ADDENDA #004

TO THE PROPOSAL FOR: RFP024-07 ARPA Parking Lot Paving Hunter Golf Club

FOR: City of Meriden

General Location Plan For Proposed Repaving At Hunter Memorial Golf Course Sheet 1 - Parking Lot		DATE: 08/24/23
DEPARTMENT OF PUBLIC WORKS		DESIGN: JPL
Engineering Division		DRAWN: BBD
City Hall  Room 19 Meriden, Connecticut		SCALE: 1" = 20'
		DWG. SHEET 1 OF 2

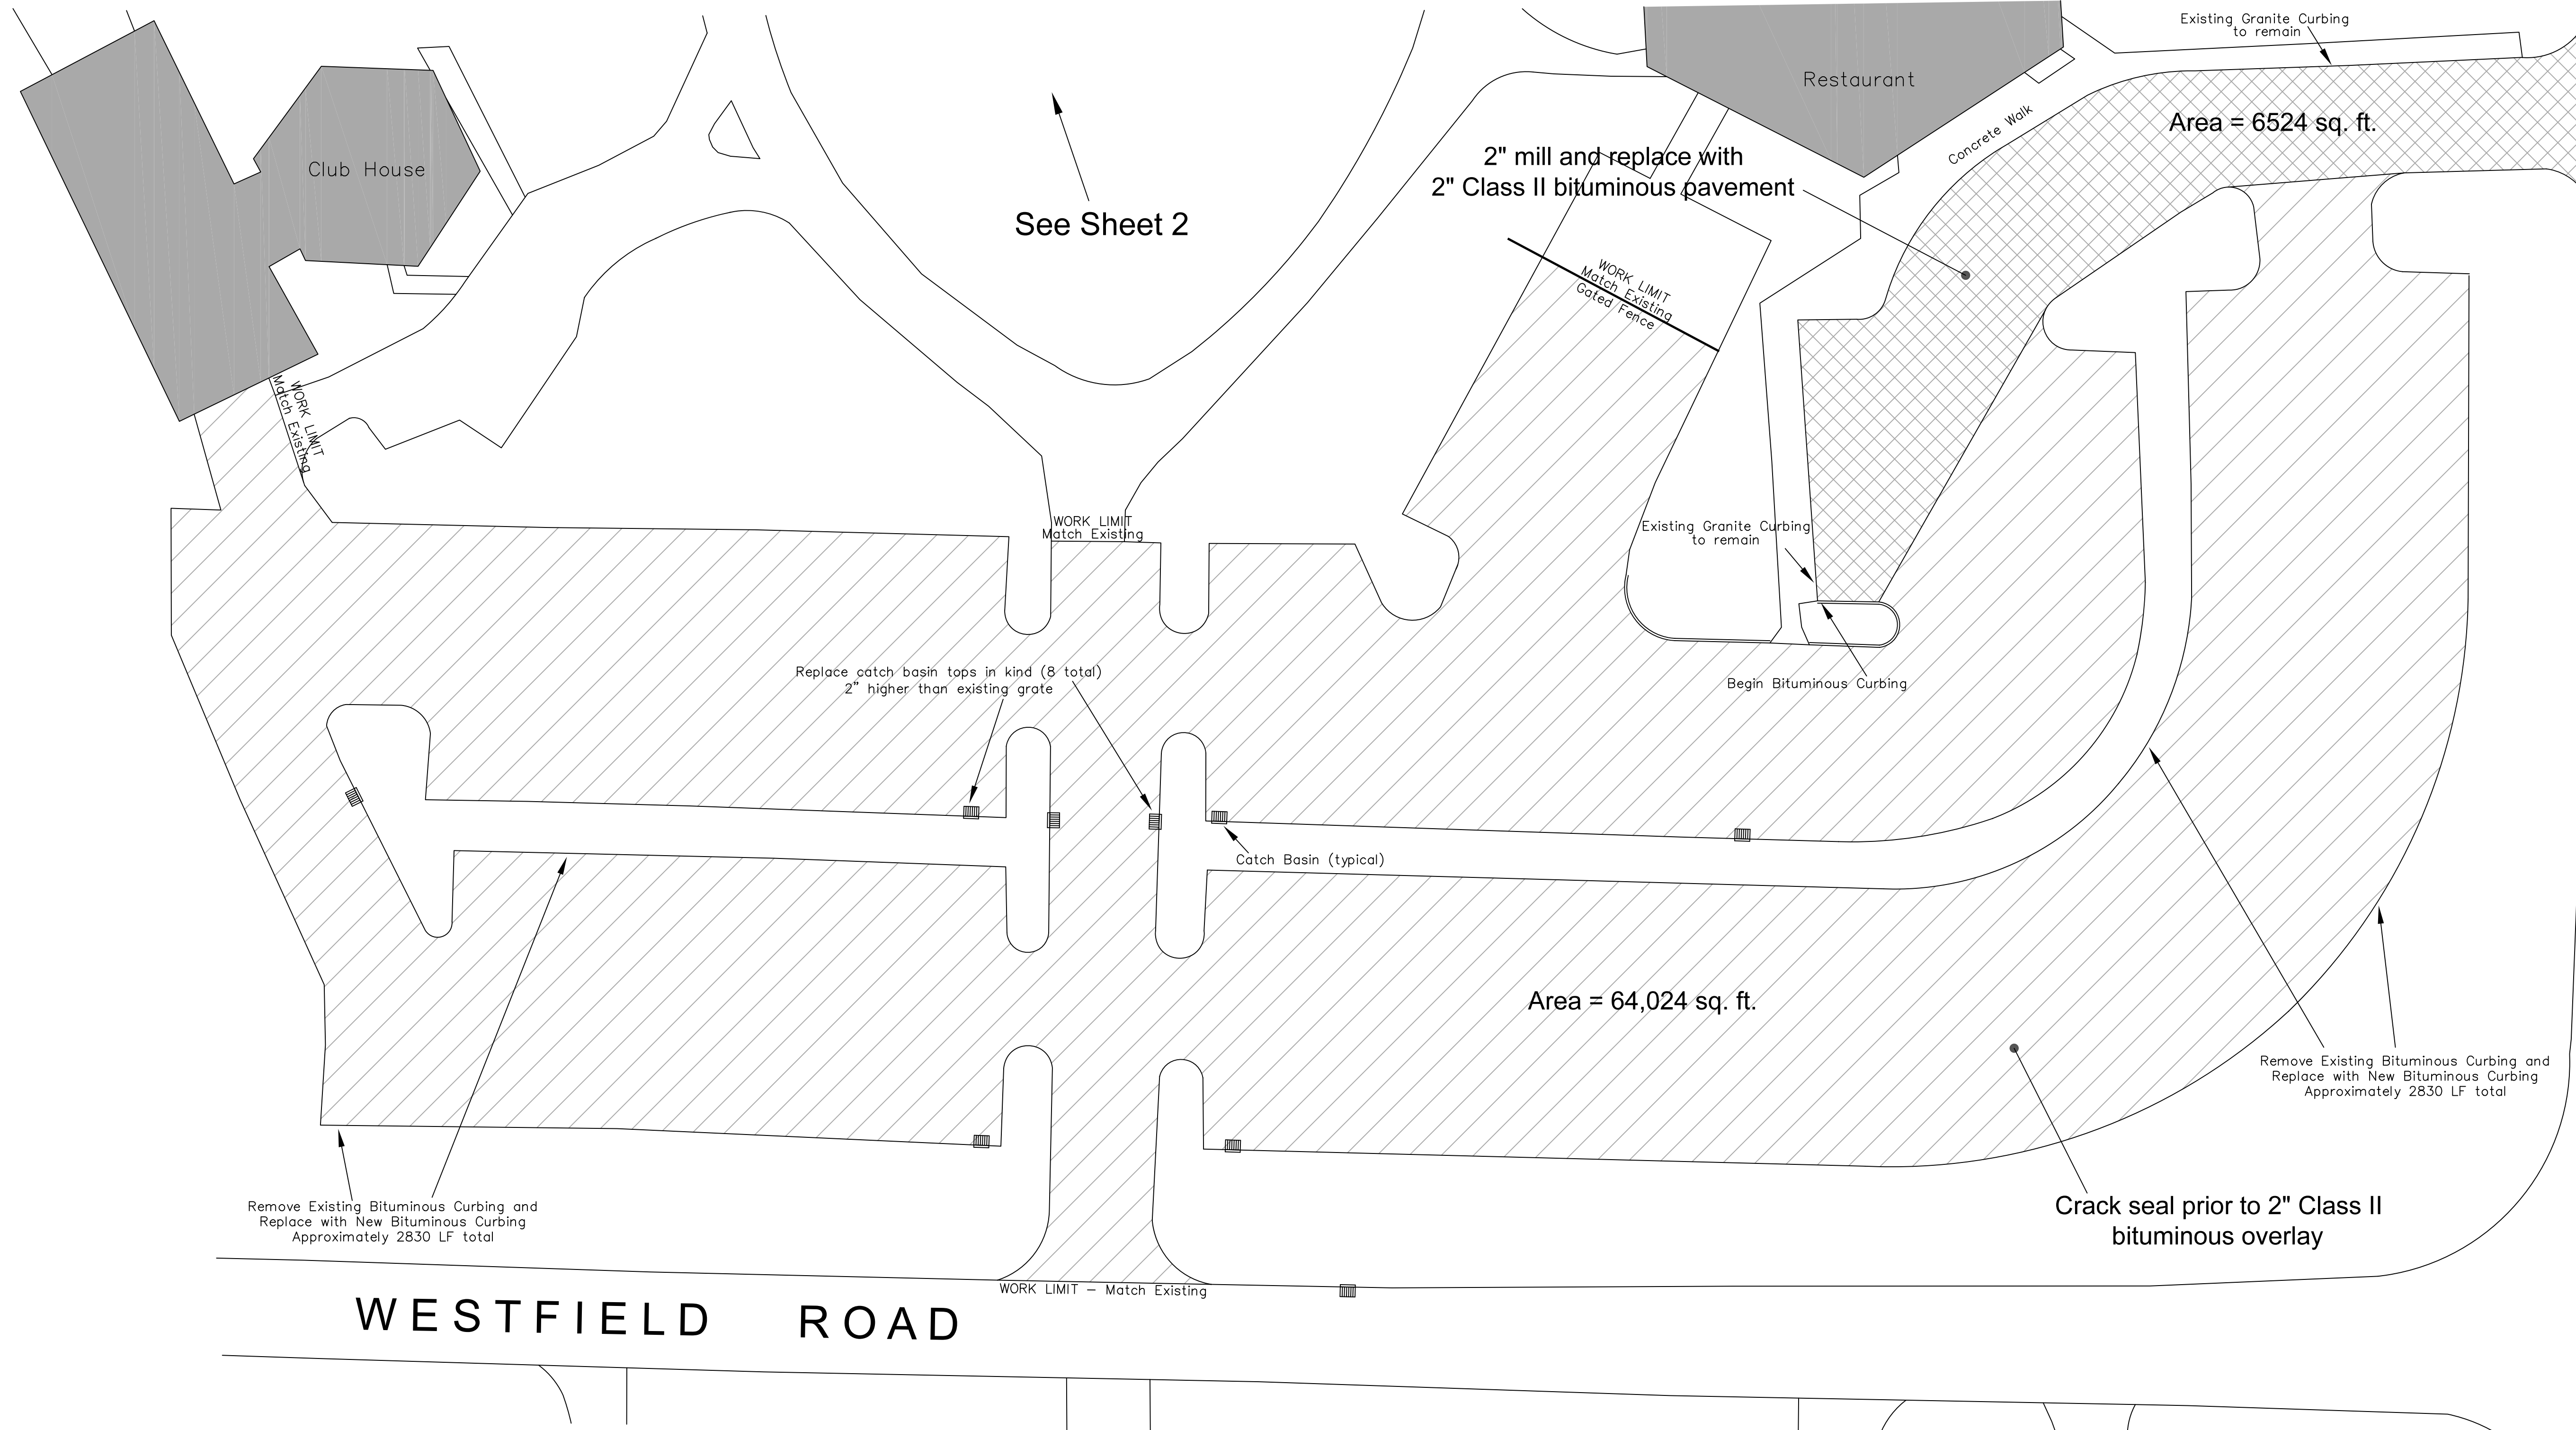
Answer: Eight (8) Catch Basin tops shall be removed and replaced
3. During the prebid walkthrough it was confirmed the parking lot asphalt is to be fully removed or reclaimed. The bid form indicates a 'mill and overlay'. Please make necessary corrections. Please confirm the thickness for new pavement in the parking lot is to be 1.5" HMA S0.5 binder and 1.5" HMA S0.375 top. And the maintenance road is to be 2" of HMA S0.375 in one course.

Answer: Please see map attached and bid form with requirements
Is the contractor responsible for installing topsoil and seed following replacement of asphalt curb?
